# *Final Value Engineering Study Report*

## *Widening of Hillcrest Parkway*

*CSSTP-0007-00(413), PI No. 0007413, Laurens County, Georgia*

Subject: Final Study Report  
**Widening of Hillcrest Parkway**  
City of Dublin, Laurens County, Georgia  
CSSTP-0007-00(413), PI No. 0007413

# VE ALTERNATIVE 5.0

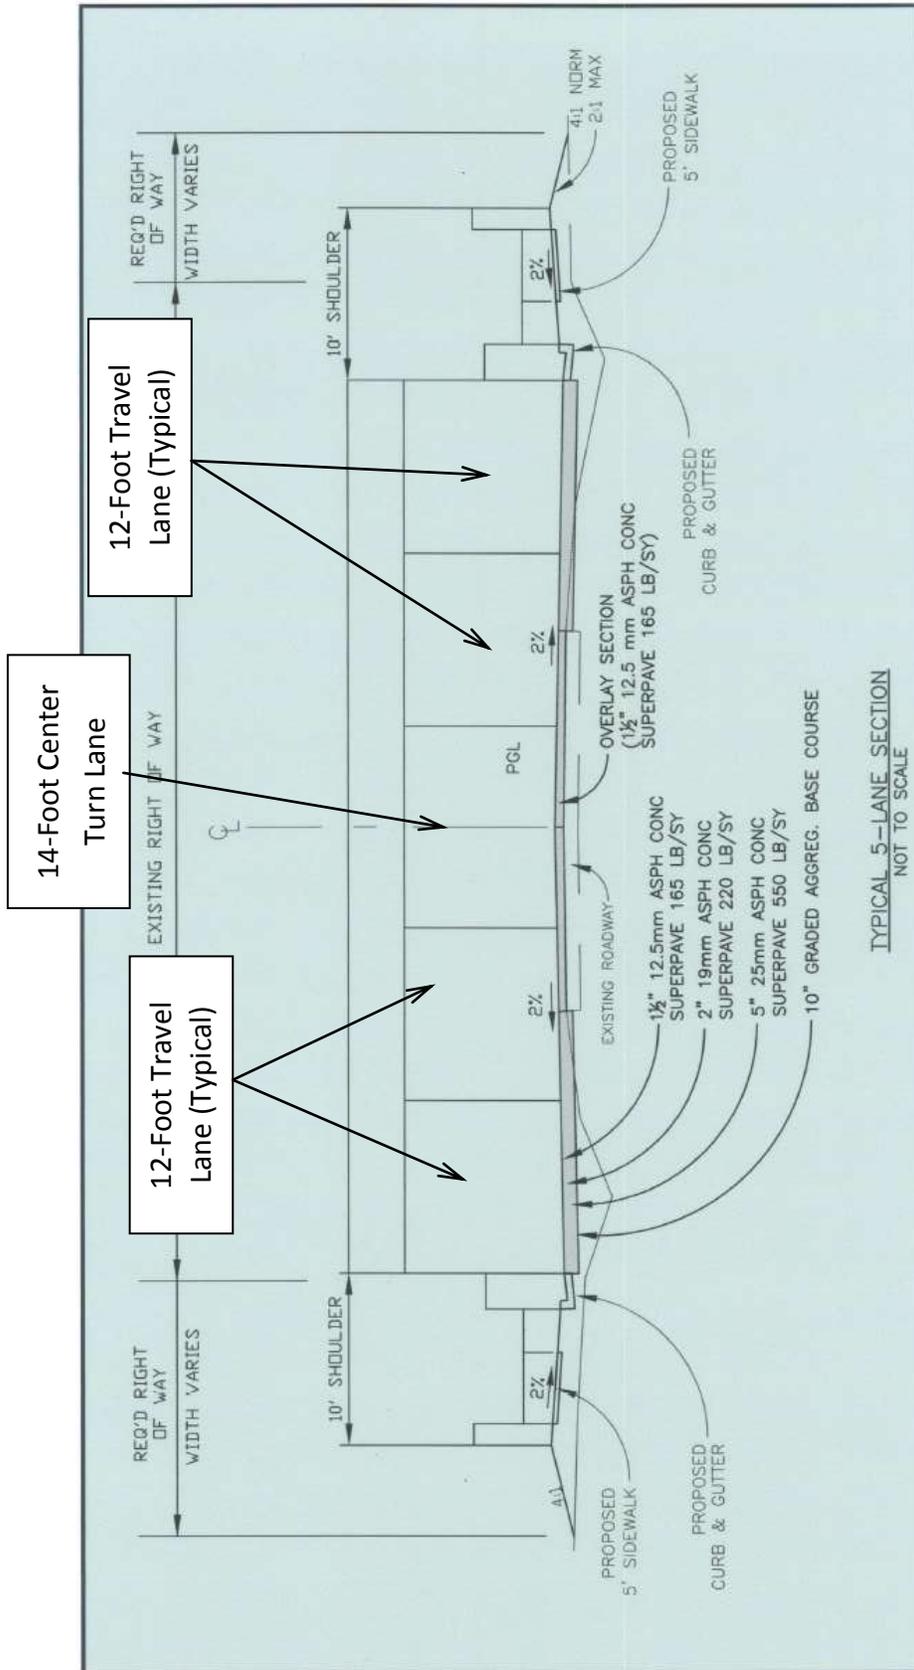
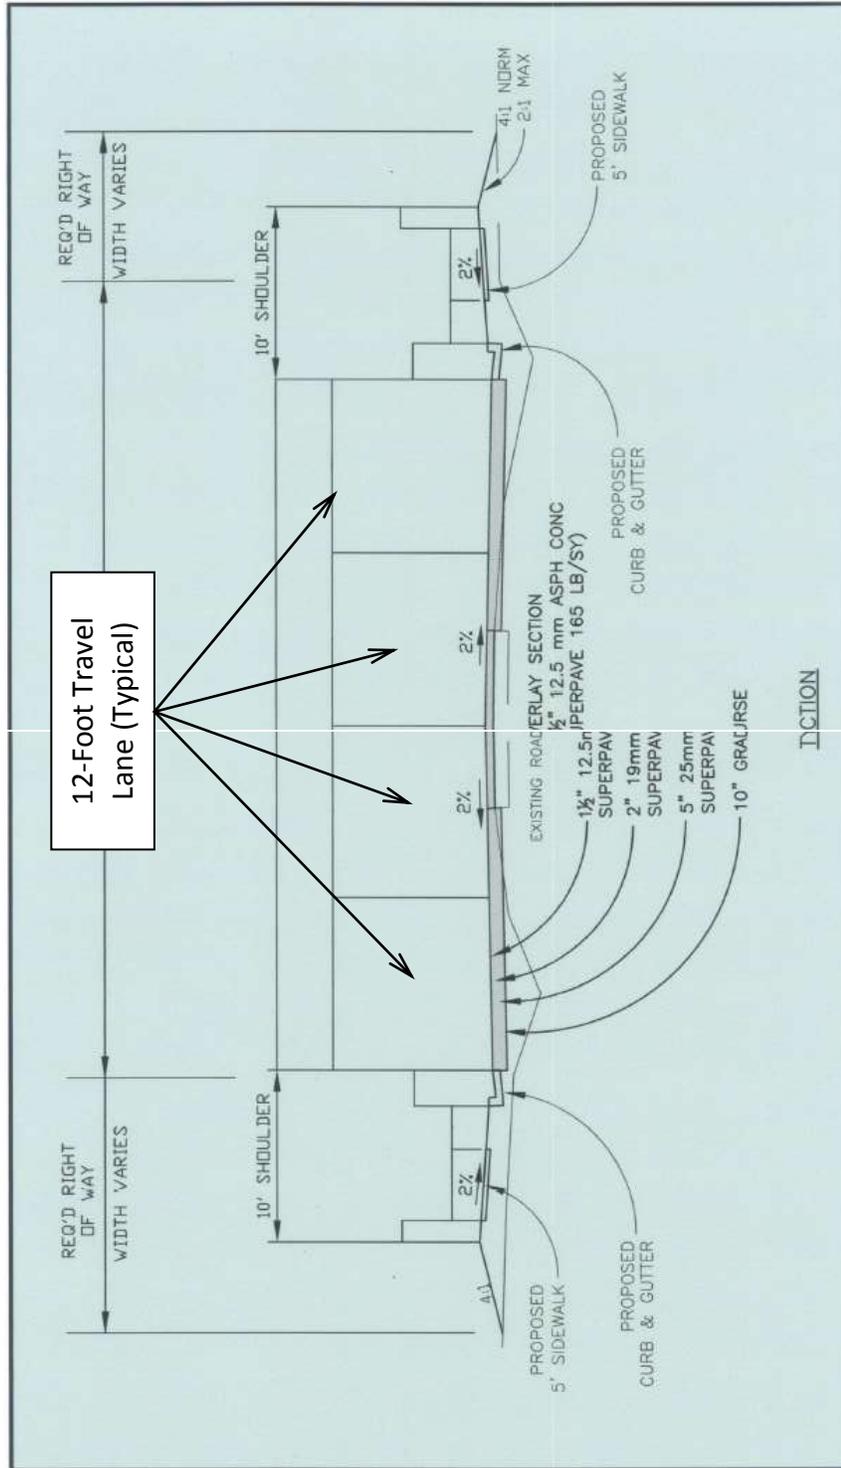
**Description of Baseline Concept:** The proposed baseline concept provides for a 14-foot center two-way turn lane along Hillcrest Parkway between Industrial Boulevard and US 80.

**Description of Alternative Concept:** Eliminate the 14-foot center two-way turn lane along Hillcrest Parkway between Industrial Boulevard and US 80.

**Discussion:** The section of Hillcrest Parkway between Industrial Boulevard and US 80 has a 27% reduction in design year traffic from the section east of US 80. Also, only Canterbury Street and three commercial driveways are located within this 2,600-foot section of the corridor. Canterbury Street accommodates only 200 cars/day and the commercial businesses each contain small parking lots. A 14-foot center two-way turn lane does not appear to be warranted in the section of Hillcrest Parkway Corridor.

# VE ALTERNATIVE 6.0

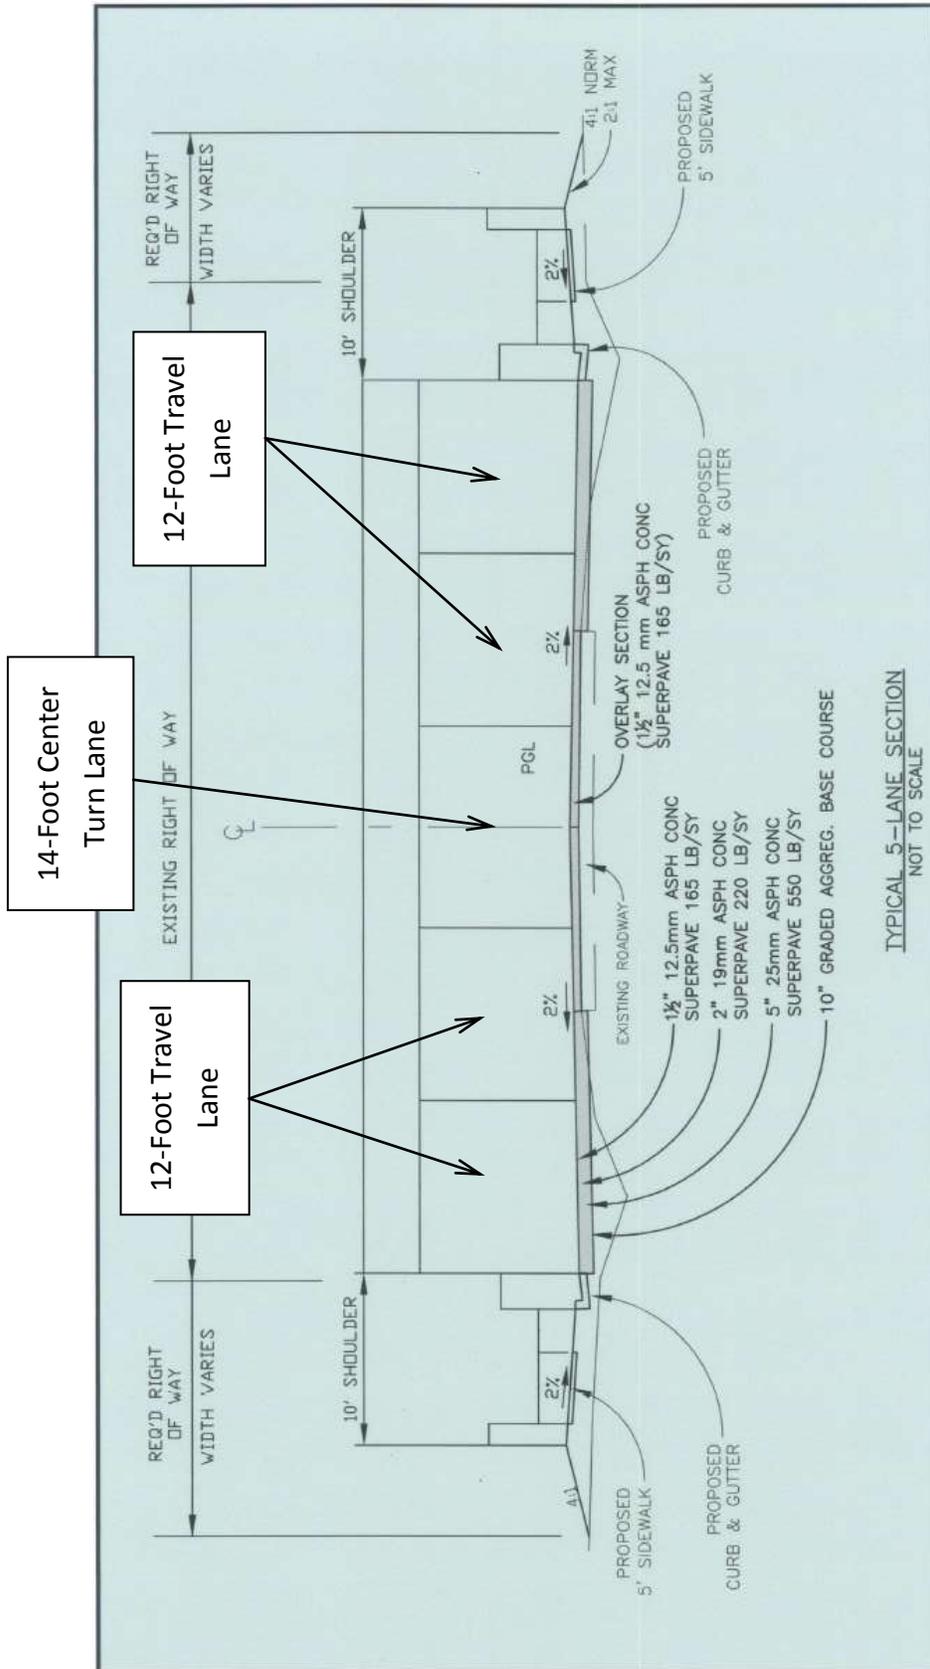
**Description of Baseline Concept:** The baseline concept delineates the use of 12-foot travel lanes throughout the corridor length.

**Description of Alternative Concept:** This alternative suggests using 11-foot travel lanes in lieu of proposed 12-foot lanes throughout the corridor length.

**Discussion:** Reducing the width of travel lanes from 12 feet to 11 feet will not impact traffic flow. The corridor has a very small percentage of truck traffic at less than 2% and the 11-foot travel lanes are widely used in urban freeways and rural areas. The reduction of 4 feet will reduce pavement and right-of-way costs while not impacting the need and purpose.

# VE ALTERNATIVE 7.0

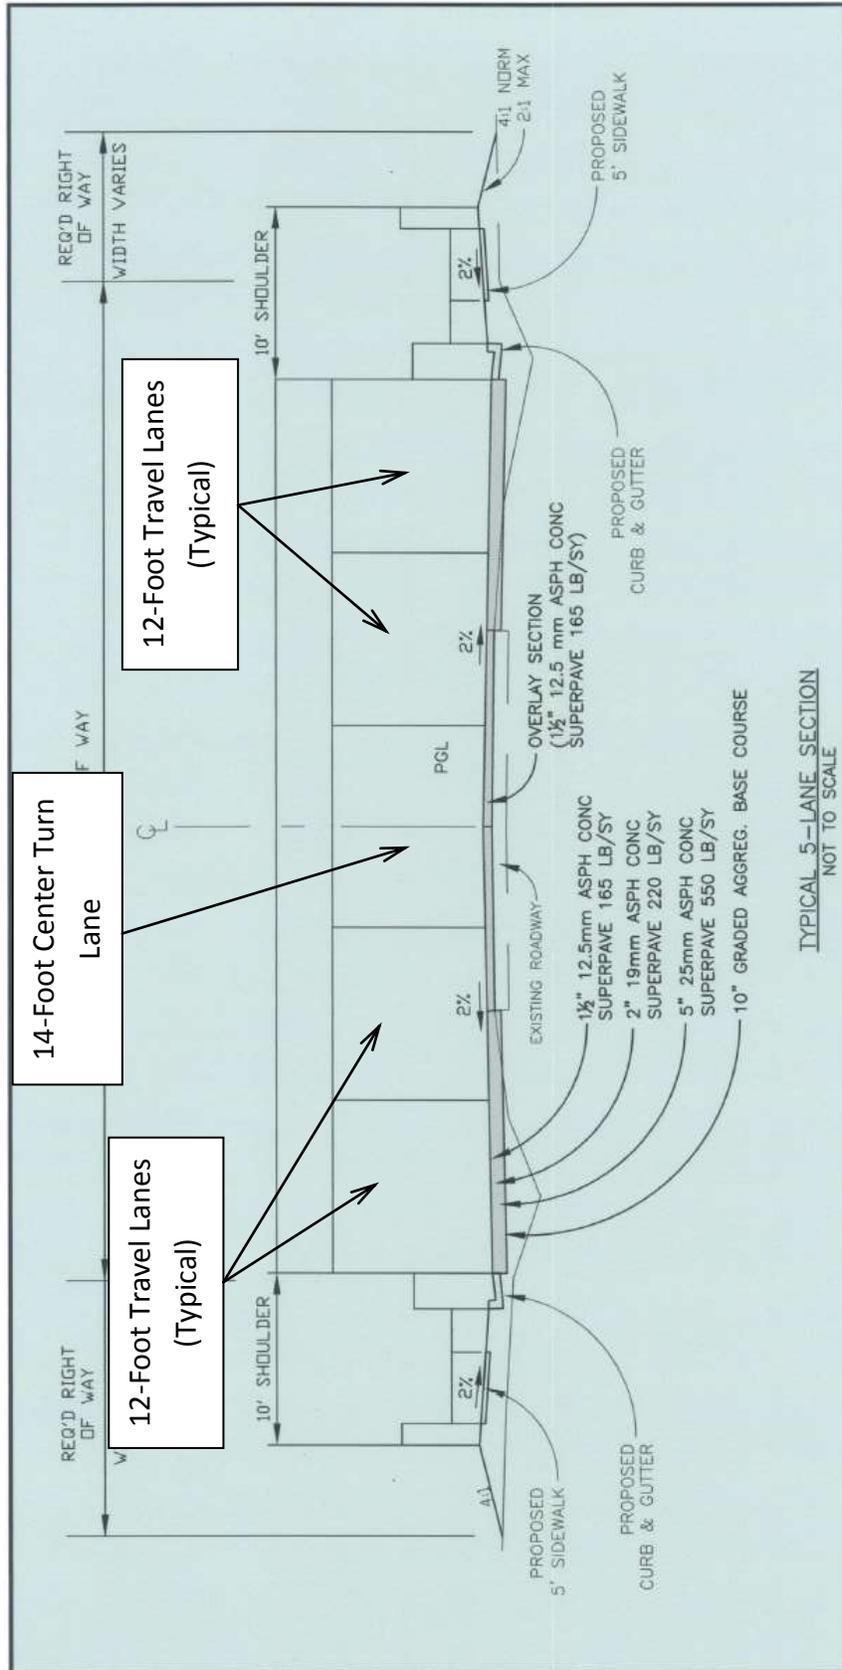
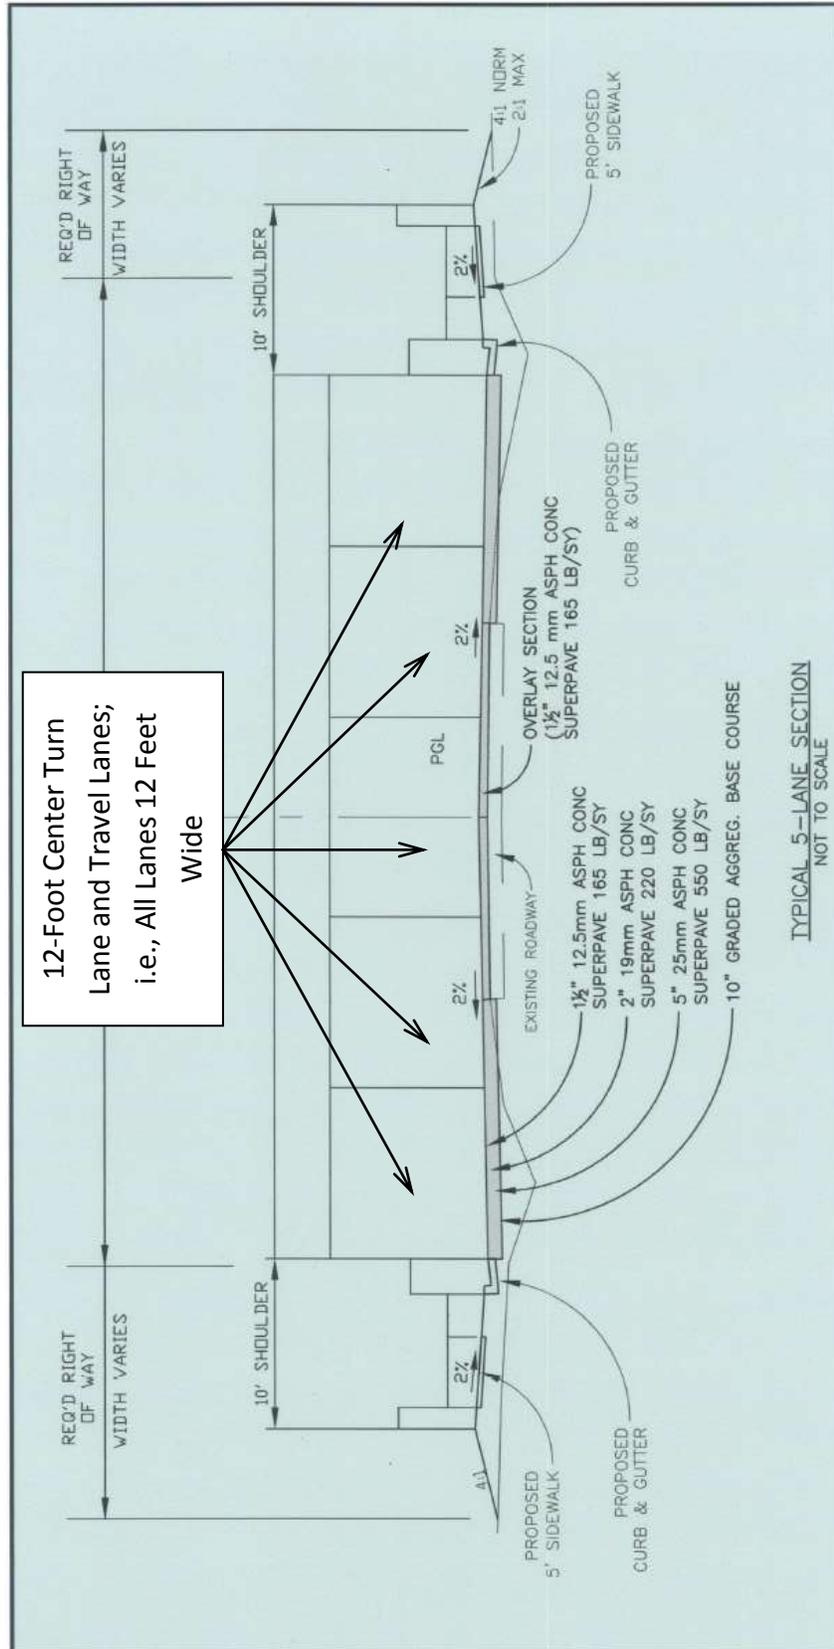
**Description of Baseline Concept:** The baseline concept uses a 14-foot center, two-way turn lane throughout the length of the corridor.

**Description of Alternative Concept:** This alternative suggests using a 12-foot center, two-way turn lane in lieu of 14-foot lane throughout the length of the project.

**Discussion:** Reducing the width of the center turn lane from 14 feet to 12 feet will not impact traffic flow. The corridor has a very small percentage of truck traffic at less than 2% and a 12-foot center, two-way lane will easily accommodate left-turning movements. The width of the travel lanes do not change at 12 feet. The reduction of 2 feet will reduce pavement and right-of-way costs while not impacting the need and purpose.

# VE ALTERNATIVE 8.0

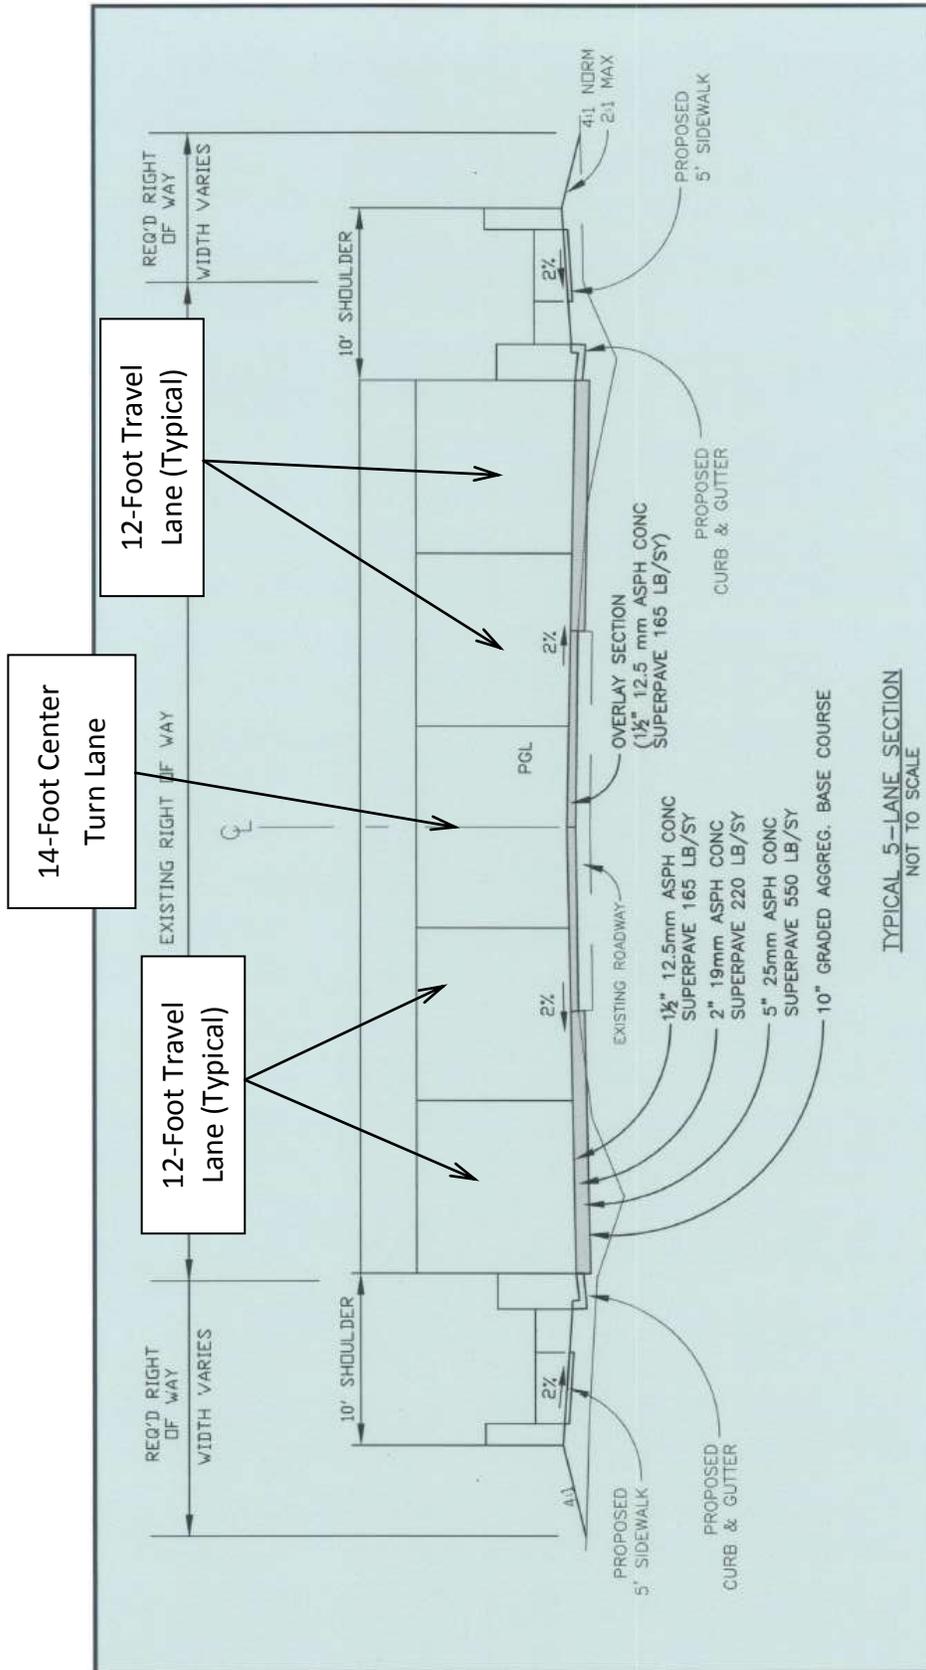
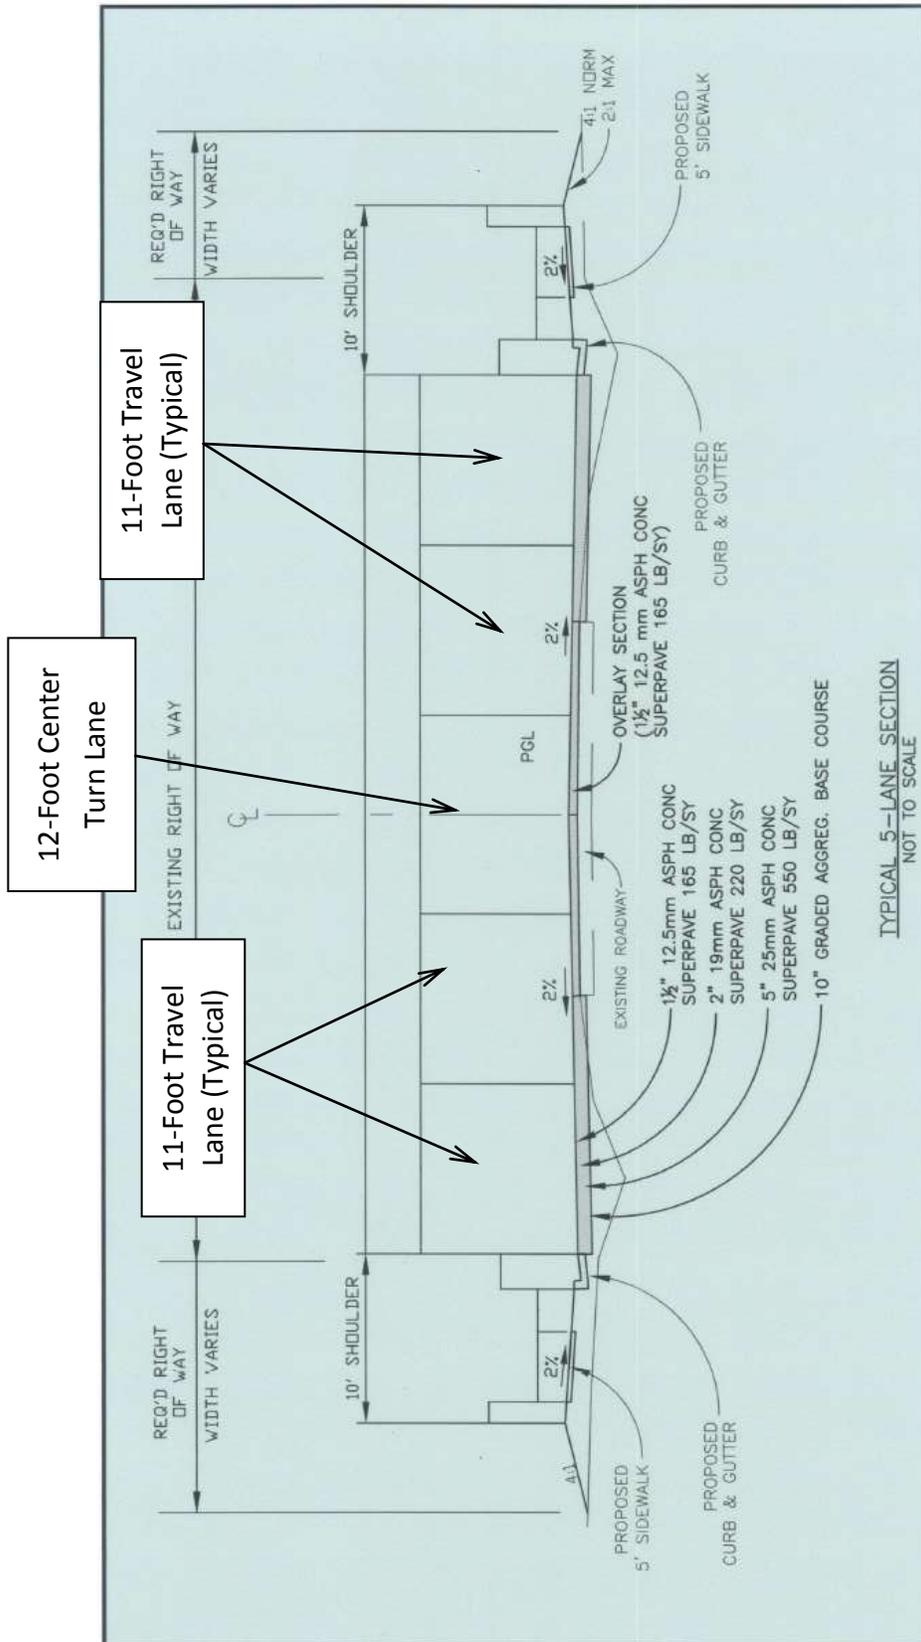
**Description of Alternative Concept:** This alternative proposes to provide 11-foot travel lanes with a 12-foot, two-way center turn lane.
